BACnet Errata
ANSI/ASHRAE STANDARD 135-2016
A Data Communication Protocol for Building Automation and Control Networks

November 1, 2019

This document lists all known *errata* to ANSI/ASHRAE Standard 135-2016 as of the above date. Each entry is cited first by clause, then page number, except where an erratum covers more than one clause. The back page marking identifying the electronic publication of Standard 135-2016 is “Product code: D-86451 6/16”.

Figure 15-5. By Time with a Positive Count

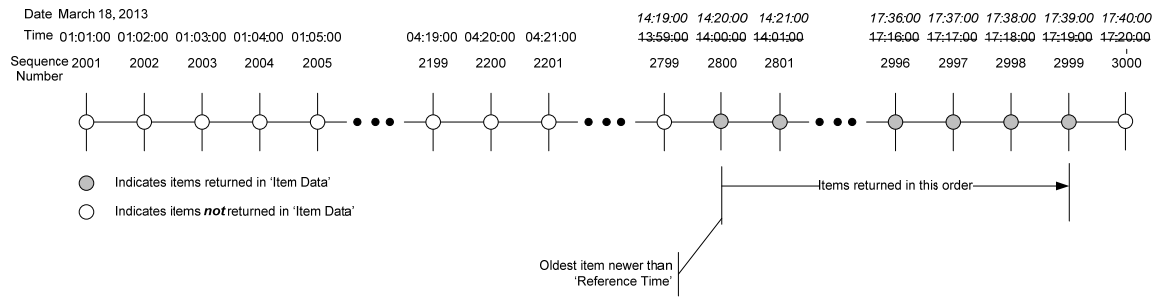
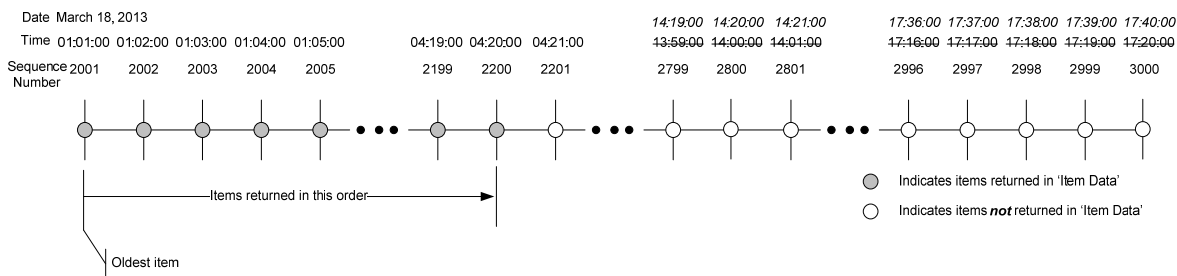
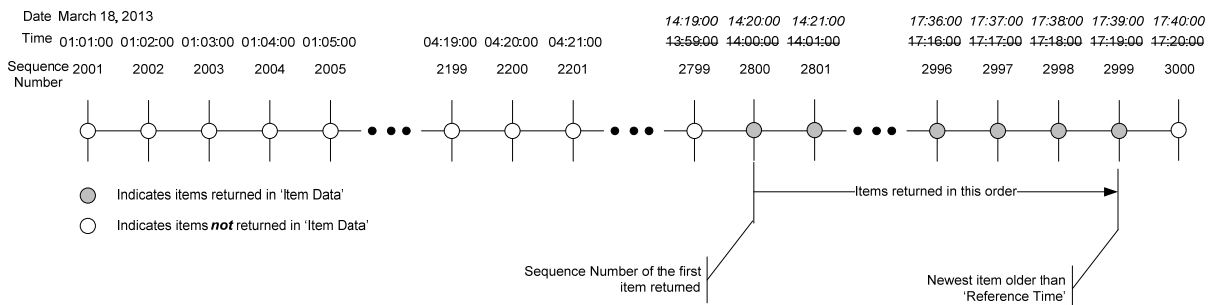
- 37) **Clauses 15.8.1.1.4.3.3, 15.8.1.1.4.3.4, 15.8.1.1.4.3.5**, p. 695, 696: The time scale in the examples is erroneous.

Assume a device contains a list with 1000 items and is capable of returning 200 items in a ReadRange response. The ReadRange service request contains a 'Reference Time' = March 18, 2013, ~~14:19:00~~ *14:19:00* and 'Count' = 300. The resulting ReadRange service response contains 200 items from March 18, 2013, ~~14:20:00~~ *14:20:00* to March 18, 2013,

~~17:19:00~~ 17:39:00 with FIRST_ITEM = FALSE, LAST_ITEM = FALSE, and MORE_ITEMS = TRUE. The 'First Sequence Number' = 2800.
